ADDRESSEES	: Owners and operators ABC Customer Care and Parts Source
VEHICLE MODEL	: TD925US
MANUAL SECTION	: 14.10 Electricity – wiring
BULLETIN TYPE	: Field Change Program
DATE	: February 05th, 2020
SUBJECT	: To optimize power supply of fuse holder ZB3 in junction box EKA
TERMS & CONDITIONS	: Refer to the warranty section further in this Bulletin.

Figure 1: In luggage compartment, location of concerned 6mm² power supply wire on grid panel of junction box “Vanner”

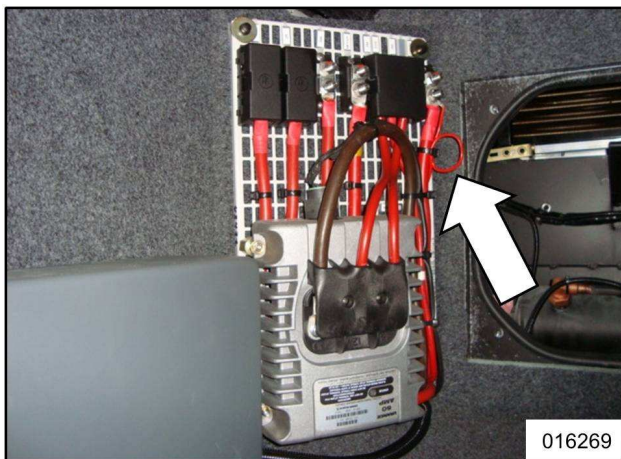
It has been reported that the red 6 mm² power supply wire connected at stud “MP+24V” in junction box “Vanner” is not protected by a fuse. This wire runs from stud “MP+24V” to terminal block DVB in junction box EKA, from there the wire continues to fuse holder ZB3 in junction box EKA to power fuses Z83.1 and Z86.

This service bulletin gives step-by-step instructions how to install an additional 30A in-line fuse in junction box “Vanner” to make sure that this wire is protected against overheating in case of overcurrent.
